Item: E-Bid #20100118 CO #3 Becker Road Widening Project, Segment 3

CHANGE ORDER

RE: BECKER ROAD WIDENING, SEGMENT #3
FELIX ASSOCIATES OF FLORIDA, INC.
CONTRACT NO. 20100118
CHANGE ORDER NO. 3

Project:
Becker Road Widening – Segment 3
(Contract # 20100118)

PROJECT Concrete Flume @ Quads on Becker Rd.

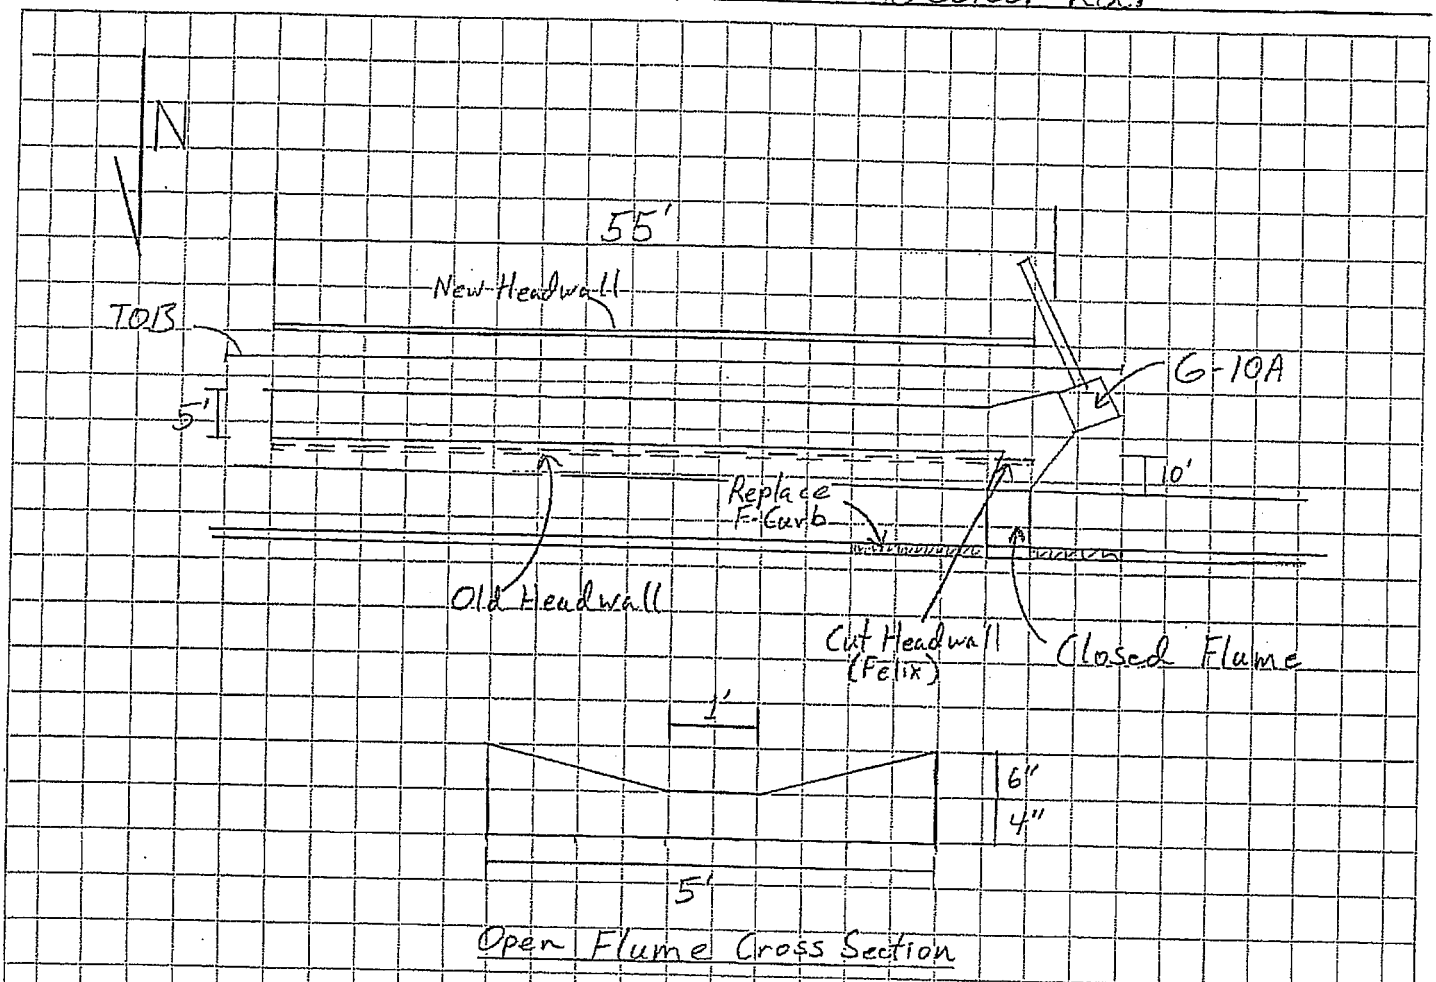
Modifications at Quad Culverts – It was determined by the City and AECOM that the roadway and back of sidewalk drainage could perform more efficiently through some slight modifications including, relocating closed flume structure, constructing concrete swale, and notching existing ditch bottom inlet (DBI). Also, an aluminum guiderail was added along the back of sidewalk at the flume. The total

The contract is changed as follows: To increase existing contract pay items and add pay items to relocate structure G-10 construct a concrete swale, cut structure G-10A and G-51, re-grade sub-grade/fine grade.

Item	Description	Qty	U/M	Rate	Total
FL	Open Flume per drawing	65	LF	45.00	2,925.00
FC	Type 'F' Curb-hand work upcharge on contract price	25	LF	10.00	250.00
MISC-ITEM	Thickened edge for sidewalk (qty approx)	14	LF	14.00	196.00
